KANSAS GAS AND ELECTRIC COMPANY

July 20, 1984

Subj: Technical Specifications

TECHNICAL SPECIFICATION CHANGES

FIGURE 6.2-1
OFFSITE ORGANIZATION

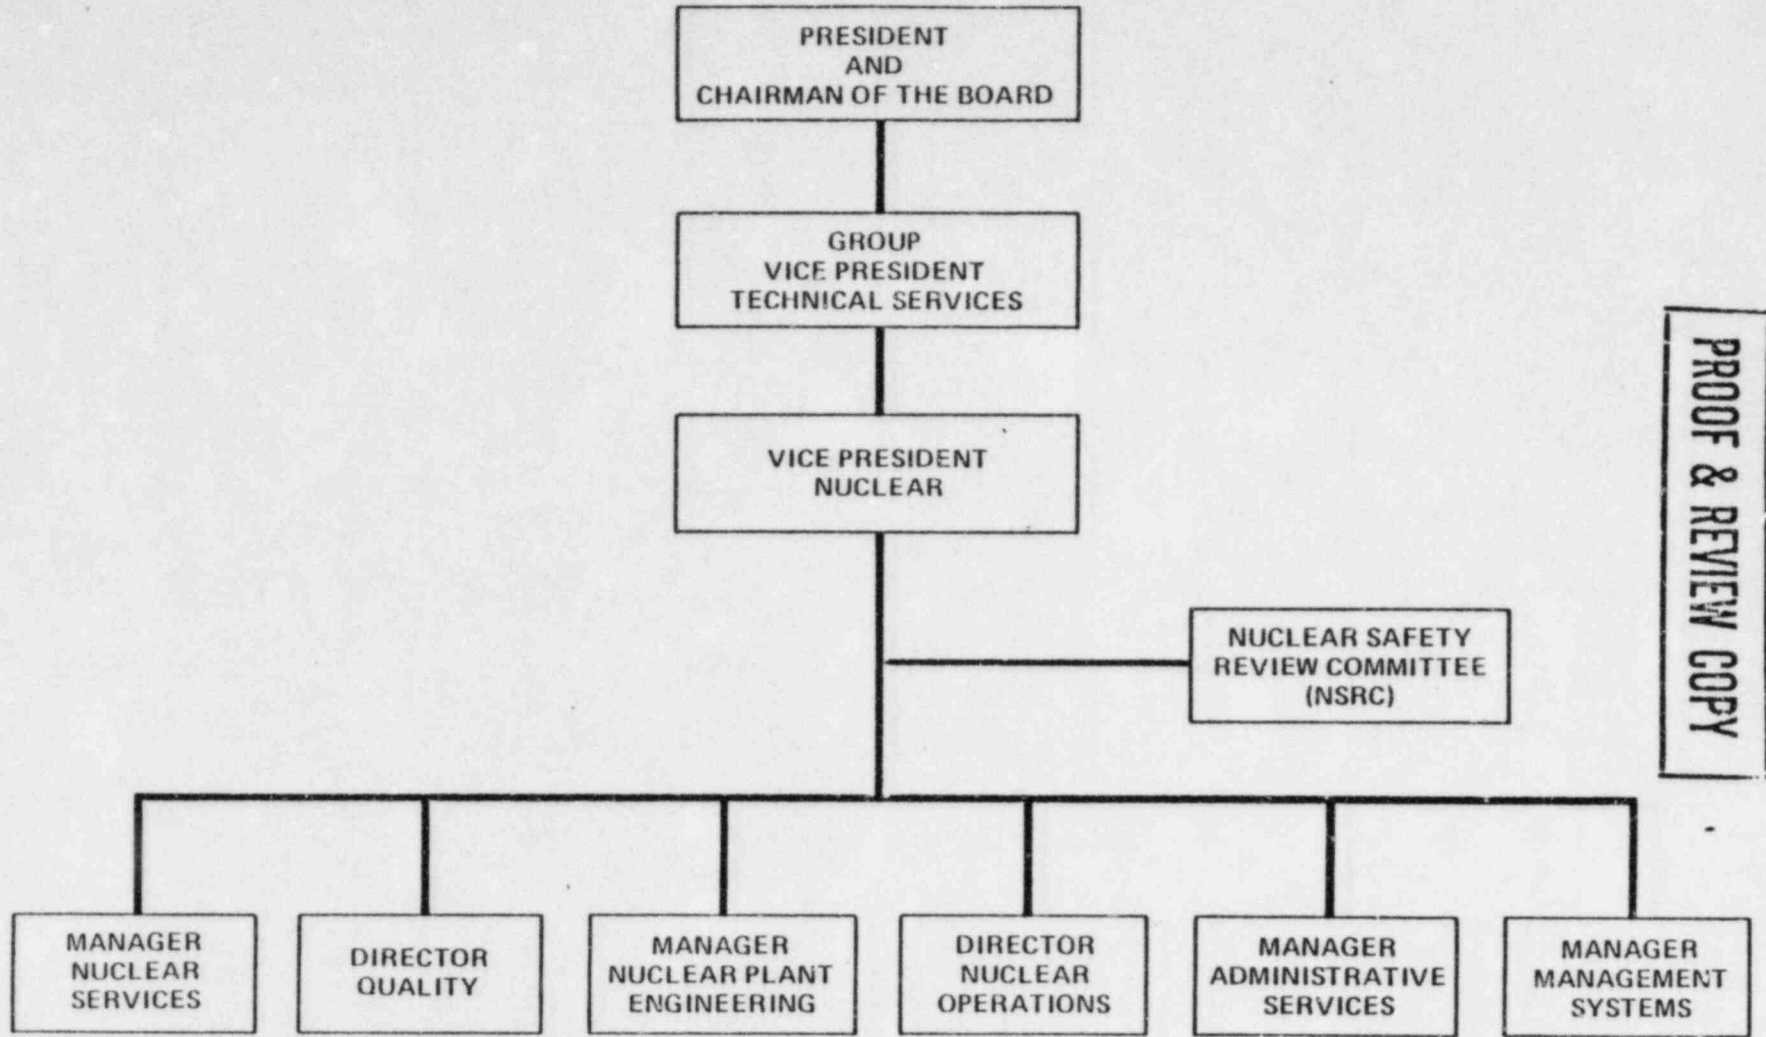
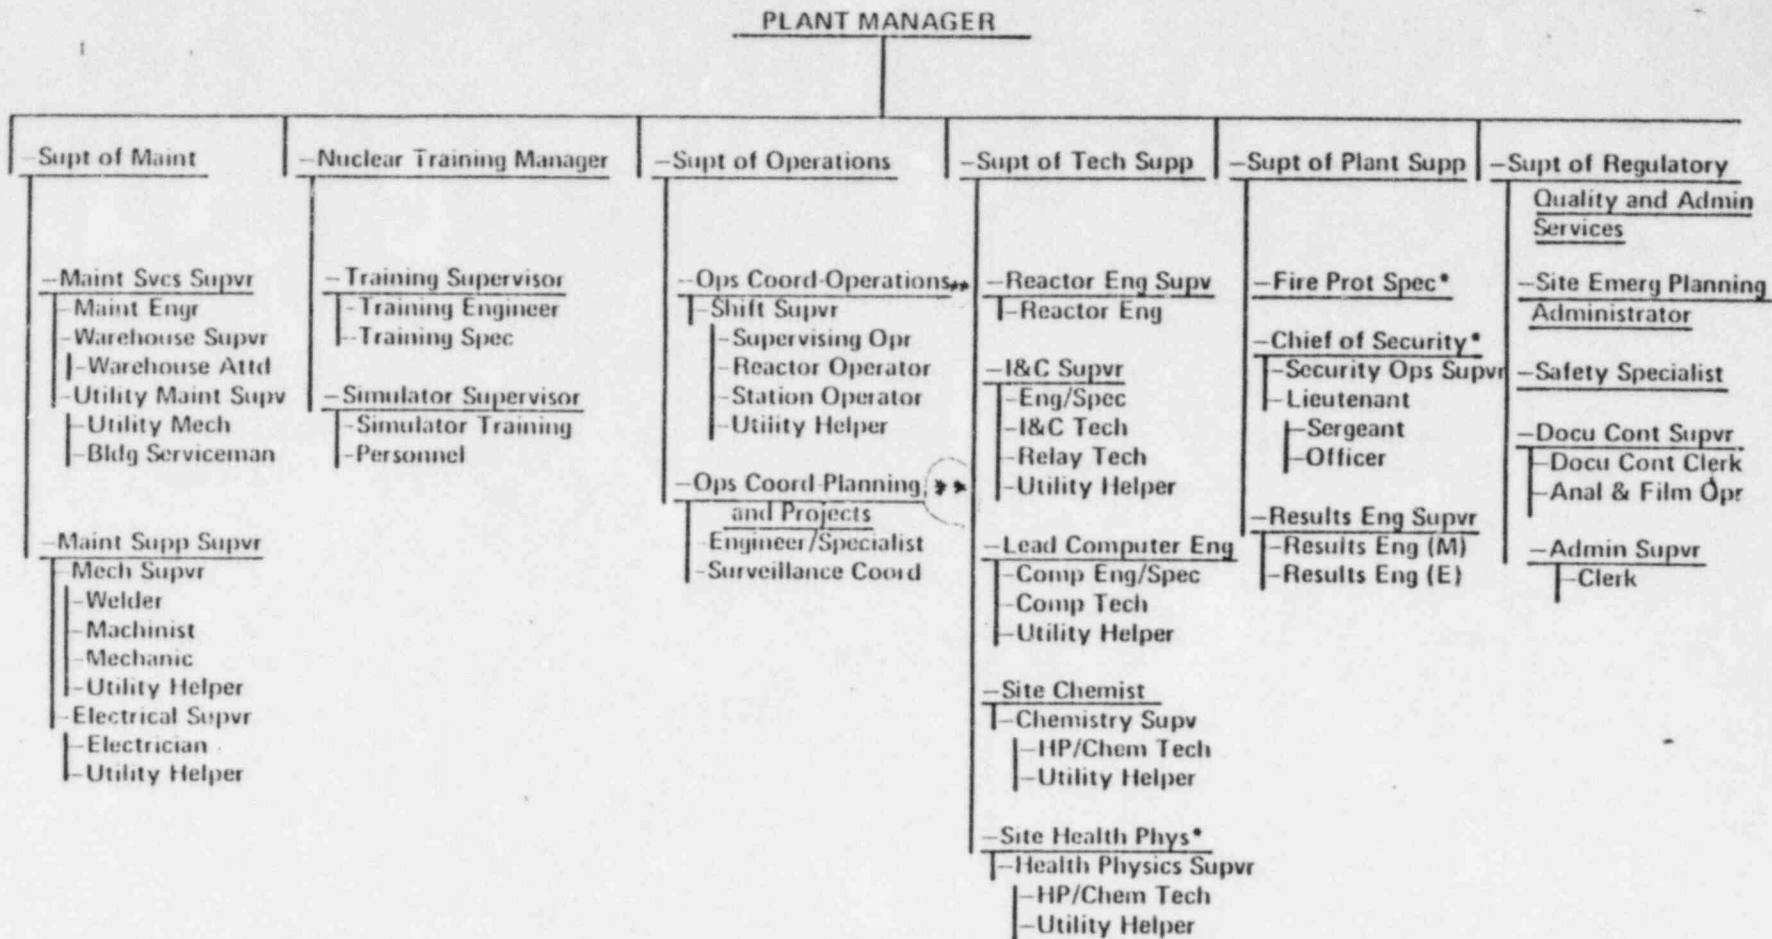
Note - The organizations depicted in the Wolf Creek "Proof and Review" copy of Technical Specifications in Figure 6.2-1 (pg. 6-3) and 6.22 (pg. 6-4) are as they existed for Wolf Creek Operations in 12/83. However, the most recent organizations are shown in the Wolf Creek PSAR site addendum. In order to reduce the number of changes needed to be made to the Technical Specification figures between now and fuel load, these figures will be updated just prior to fuel load.

- (1) the term Site Boundary is defined in Section 1.29 (page 1-5) of the Technical Specifications.
- (2) Several important structures at Wolf Creek are located outside of the "Protected Area" which is often used by regulatory authorities as the boundary for the term "Onsite." These structures include: Fuel Oil Storage, Circulating Water Screenhouse, Switchyard, and support buildings.
- (3) The ESW pumphouse though located in a "Protected Area" is located some distance (1500-1800 feet) from the Power Block.
